# JRPP PLANNING REPORT

<b>JRPP NO:</b>	2009SYW028
<b>DA NO:</b>	891/2010/JP
<b>APPLICANT:</b>	John R Brogan and Associates Pty Ltd
<b>PROPOSAL:</b>	Demolition of Existing Structures and Construction of a Bulky Goods Retail Development for Bunnings Warehouse
<b>PROPERTY:</b>	Lot 1 DP 796954, No. 14 Victoria Avenue, Castle Hill
<b>LODGE MENT DATE:</b>	12 December 2009
<b>REPORT BY:</b>	Gavin Cherry – Development Assessment Coordinator The Hills Shire Council
<b>RECOMMENDATION:</b>	Approval

## ATTACHMENT 8 – ELEVATION DRAWINGS

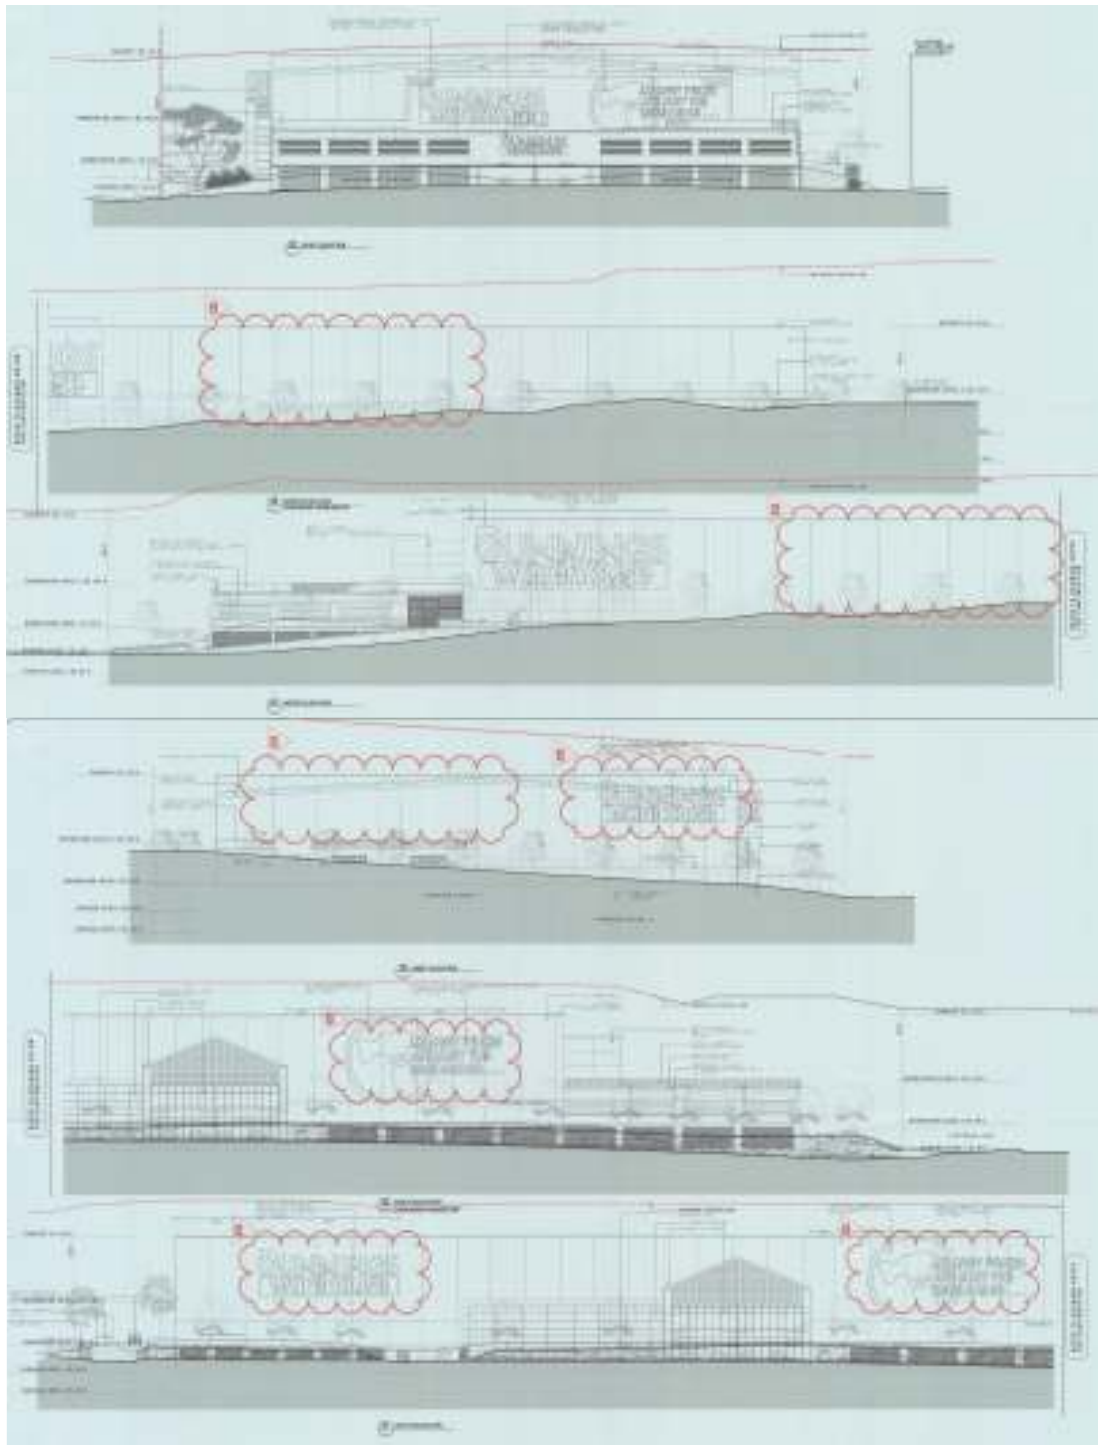
The original Development Application lodged with Council for consideration provided a total signage area of 1,950.71m<sup>2</sup>. This proposed signage area was considered unsatisfactory and out of scale with the proposed building. In response to Council's requests, the applicant provided amended signage detail reducing the proposed signage area to 881.87m<sup>2</sup>. This provision is considered to be more in keeping with the bulk and scale of the proposed development however further minor amendments are recommended to be adopted to further reduce the signage area proposed. The amendments detailed within the above table include the following:-

- Northern Elevation: 232.2m<sup>2</sup> of signage area is proposed however the scale is not consistent with other elevations and should be conditioned to be consistent with the southern elevation being 144.3m<sup>2</sup>.
- Eastern Elevation: 242.32m<sup>2</sup> of signage area is proposed however exclusion of the 28.2m<sup>2</sup> sign (considered to be excessive) reduces the signage total to 214.12m<sup>2</sup>.

Amendments in red require signage area and location to be in accordance with the elevation drawings (Drawing No. 130 and 131) and not that depicted on the sections drawings and landscape sections / elevations.
